Rezoning Transportation Analysis

Petition Number: #2022-109

General Location Identifier: 09709418

Date	Description
11-28-22	First Review (IW)
12-21-22	Second Review (IW)
01-25-23	Third Review (TM)
03-22-23	Forth Review (IW)

Reference (CLDSM standard detail U-02) for residential medium street typical.

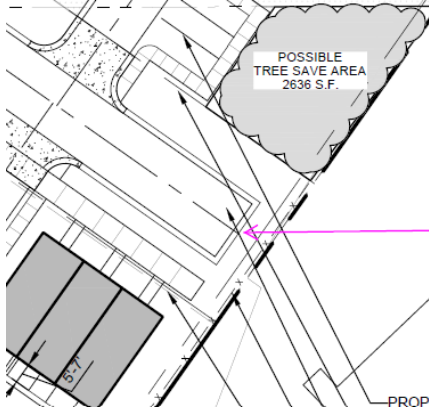
4. The proposed dwelling units exceeds 12 per acre. Per Chapter 20 Subdivision ordinance, site plan and conditional note(s) revisions are needed to commit to construct an 8-foot planting strip, and 8-foot sidewalk along all public roads. The wider sidewalk also meets the Charlotte WALKS Policy.

Outstanding Clarifying Comment 12-21-22: Petitioner should add conditional note stating commitment of 8' planting strip and 8' sidewalk along both sides of all public roads. Reference (CLDSM standard detail U-02) for residential medium street typical section. Potential environmental conflicts to be coordinated during permitting if full section cannot be achieved.
